Subject: VARIABLE VALVE TIMING (VVT) NOISE WHEN STARTING ENGINE	Bulletin No: 01-010/11
	Last Issued: 02/23/2011

- This bulletin supersedes the previous bulletins 01-043/07 issued on 11/29/07, 01-002/08 issued on 01/16/08 and 10/01/08, 01-026/09 issued on 06/30/09 and 08/28/09, and 01-028/10 issued on 05/14/10 and 08/20/10. The REPAIR PROCEDURE and PART(S) INFORMATION have been revised.
- Changes are noted below in Red beside the change bar.

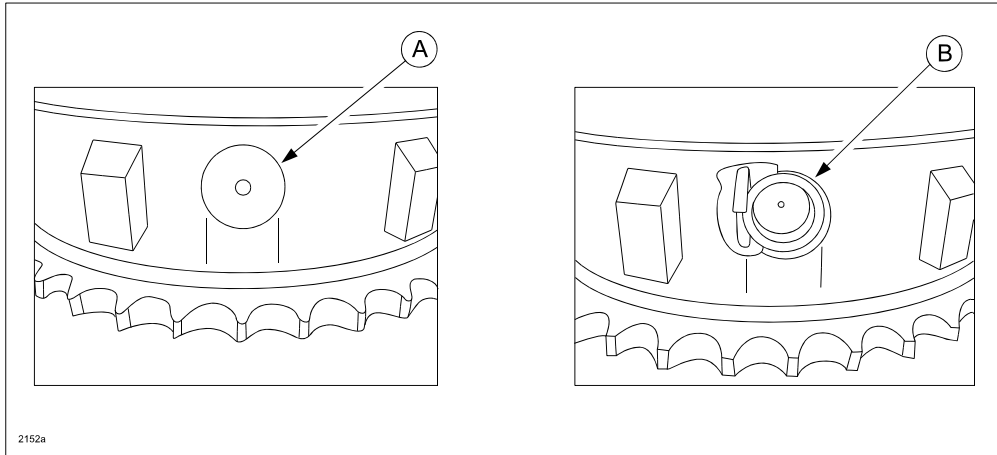
When the engine is first started, some vehicles may exhibit a loud ticking noise from the variable valve timing (VVT) (A). This is caused by the lock pin of the variable valve timing actuator not fully engaging or from a worn lock pin hole. Heat treatment has now been added around the hole of the variable valve timing rotor lock pin to prevent this from happening.

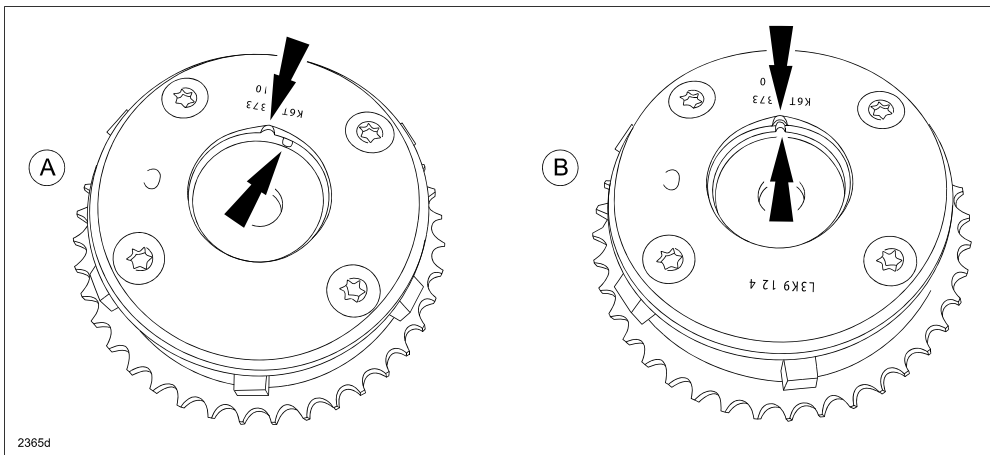
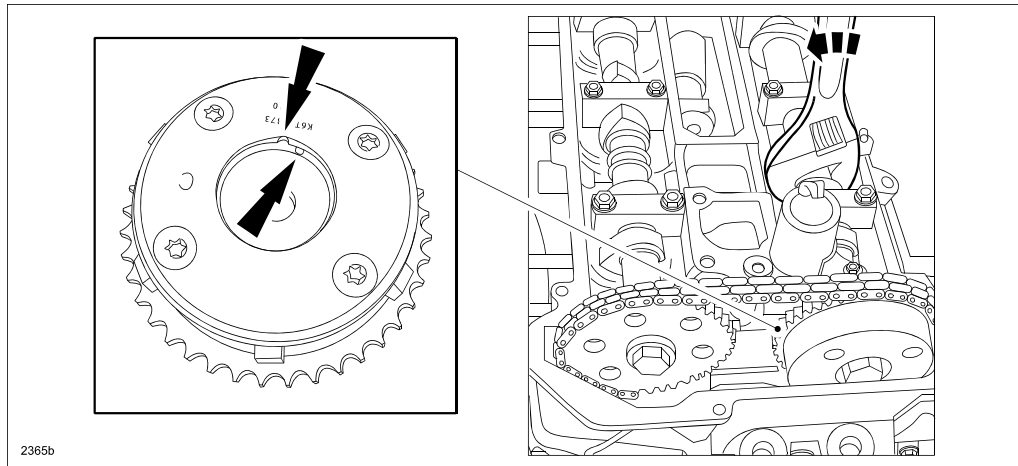
1. Verify customer concern.
2. Write down the customer's radio station presets.
3. After the engine cools down, disconnect the negative battery cable (to prevent DTCs from being stored).
4. Remove the cylinder head cover. Refer to MS3 online instruction.
5. For vehicles with turbo engines (L3T), inspect the variable valve timing actuator for damage around the stopper pin cap (A) or a missing stopper pin cap (B), spring and stopper.

- If no parts are damaged or missing, go to step 6.
 - If any parts are damaged or missing, go to step 10.
6. Turn the crankshaft clockwise so that the notches on the variable valve timing actuator can be checked.
 - A. If the notches are NOT aligned, go to the next step.
 - B. If the notches are aligned, there is no problem with the variable valve timing actuator and this information is not applicable. Refer to MS3 online instructions for troubleshooting.

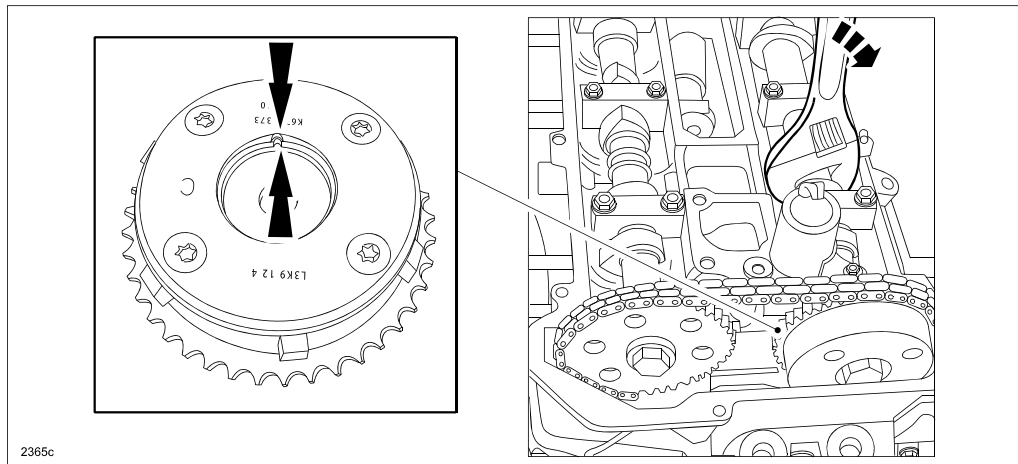
7. Turn the camshaft counterclockwise to align the notches on the variable valve timing actuator.

8. With the notches aligned, turn the camshaft clockwise 90 degrees.
